SITE PLAN
ADMINISTRATION BUILDING
FOR
DEPARTMENT OF NATURAL RESOURCES
1100 WEST NORTH TEMPLE SALT LAKE CITY, UTAH
FOR
UTAH STATE BUILDING BOARD
PROJECT I.D. NO. SBB NA: 77-069

AS BUILT

ARCHITECTURAL ADDENDUM & CHANGE ORDERS

PARTIAL FIRST FLR.
SCALE 1/8"=1'-0"
ADDENDUM NO. 1: ADD ELECT. ROOM.
REFER ATTACHED DRAWINGS
A/AB-1M; B/AB-1M; A/AB-1E

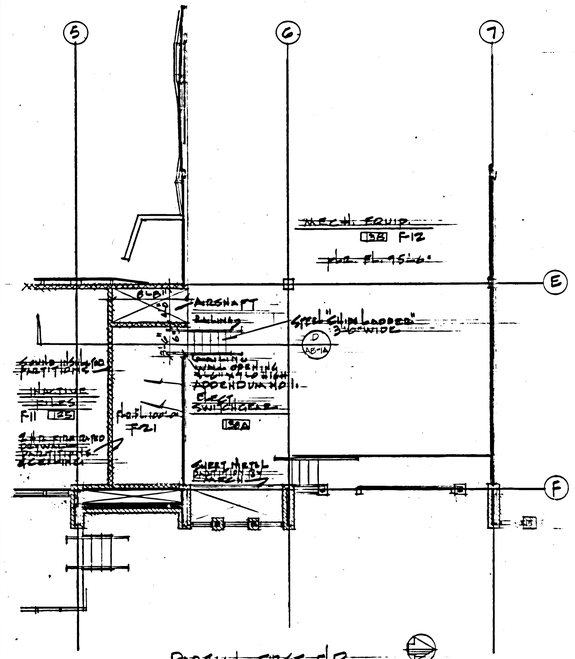
CHANGE ORDER #14

B AB-1E REVISED UNDERGROUND ELECTRICAL SUPPLY

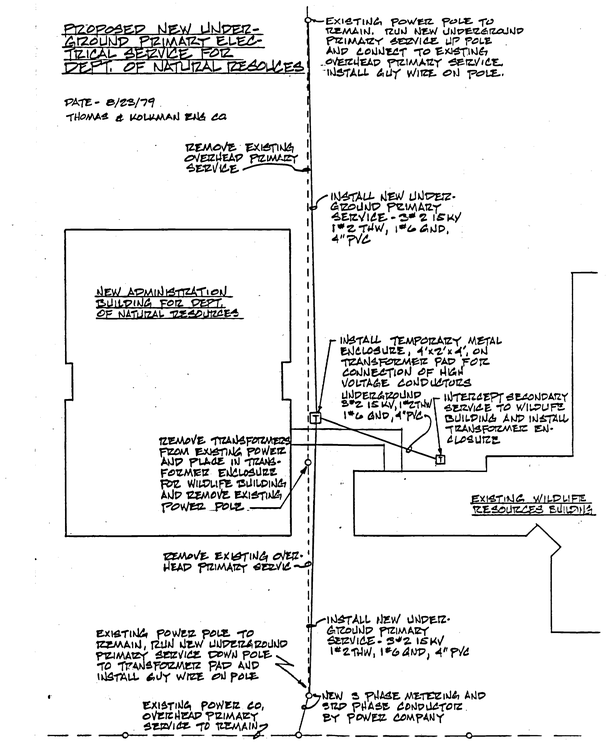
CHANGE ORDER #2

B AB-1M MECHANICAL ROOM
SCALE: 1/4" = 1'-0"

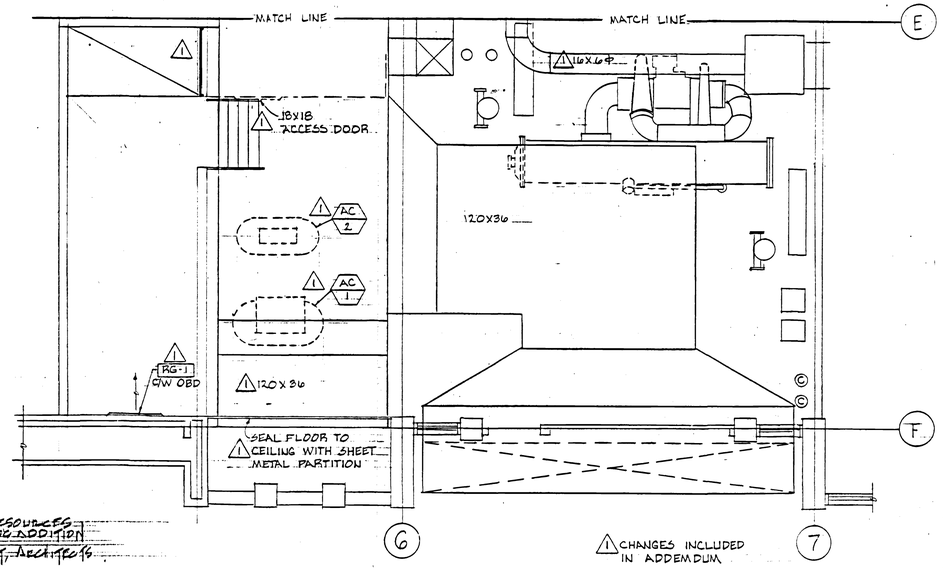
NOTES:
1- REMOVE EXISTING SILLCOCK, REROUTE WATERPIPE AND REINSTALL SILL COCK AS SHOWN.
2- REMOVE EXISTING 30" x 24" FA LOUVER, EXTEND DUCTWORK AND INSTALL NEW 30" x 24" LOUVER C/w BIRD SCREEN
3- REMOVE EXISTING 36" x 24" EXHAUST LOUVER, EXTEND DUCTWORK AND INSTALL NEW 36" x 24" LOUVER C/w BIRD SCREEN
4- REMOVE EXISTING 36" x 18" C.A. LOUVER, EXTEND DUCTWORK AND INSTALL NEW 36" x 18" LOUVER C/w BIRD SCREEN
5- PATCH WALL TO MATCH EXISTING.

FOUNDATION PLAN AT REVISED LOADING DOCK

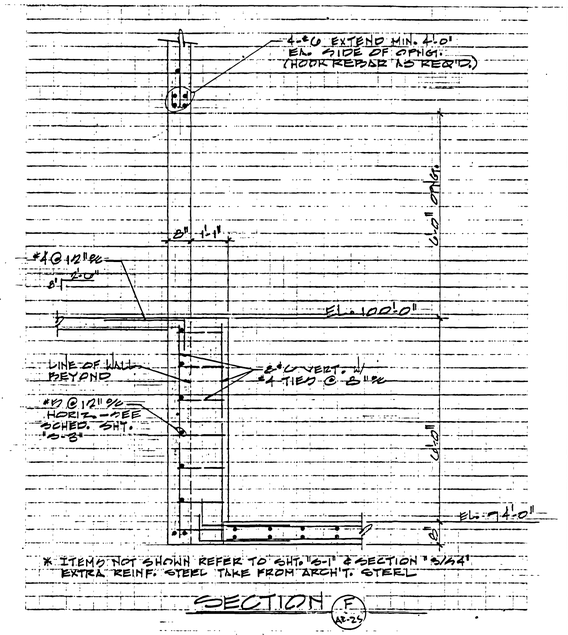
CHANGE ORDER #4

C AB-10A PARTIAL SITE PLAN
SCALE 1"=20'-0"
CHANGE ORDER #27

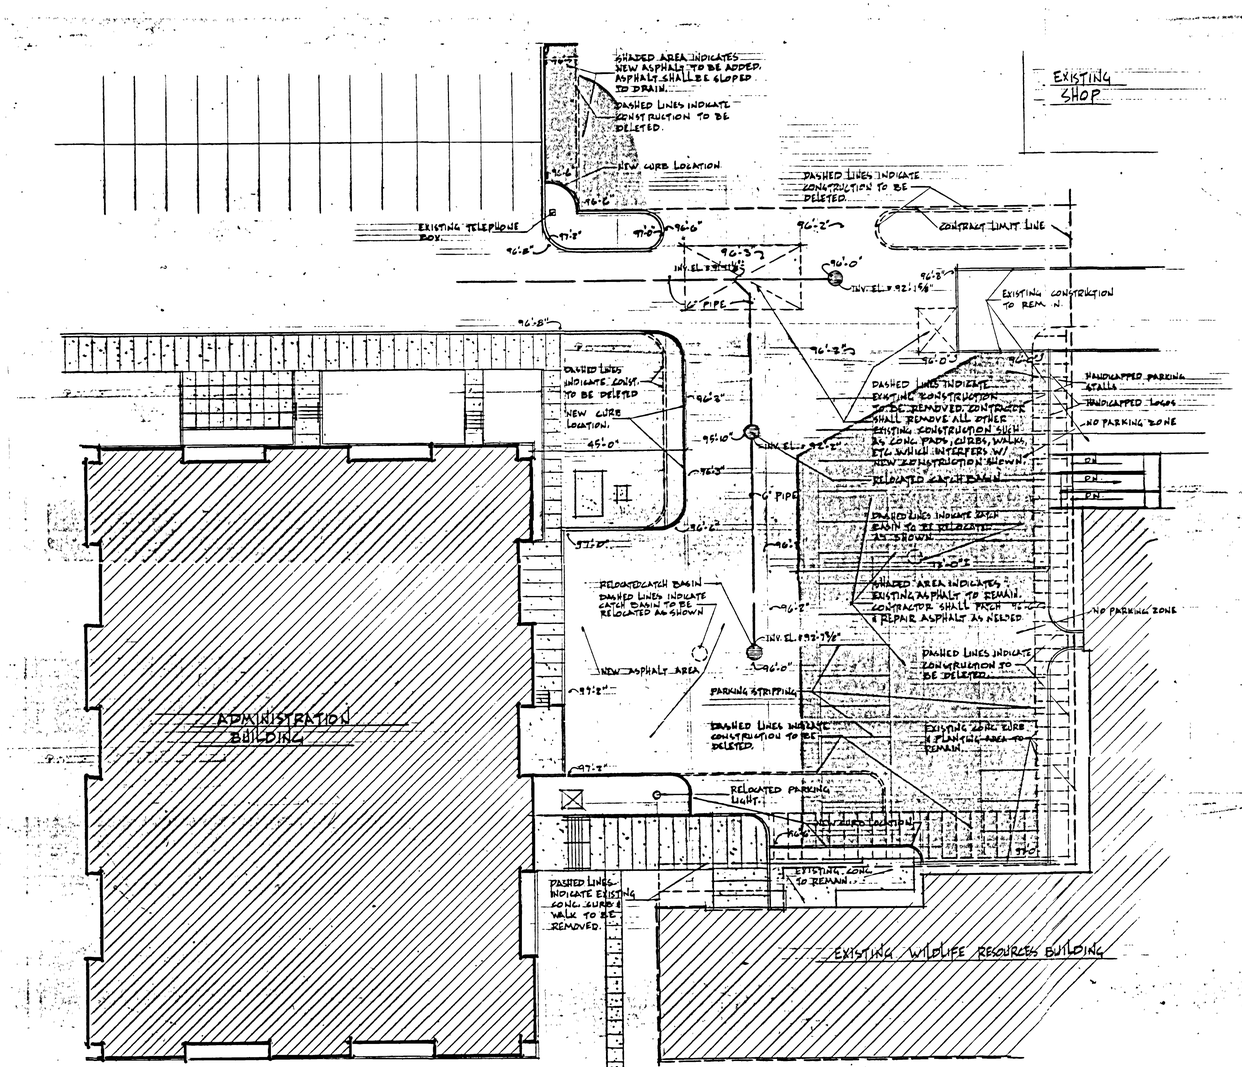
NOTE: AT AREAS WHERE NEW ASPHALT JOINS EXISTING CONTRACTOR SHALL PROVIDE A SMOOTH TRANSITION & SLOPE TO DRAIN. CONTRACTOR SHALL ALSO PATCH & REPAIR ANY DAMAGED ASPHALT LOCATED WITHIN CONTRACT LIMIT LINES.
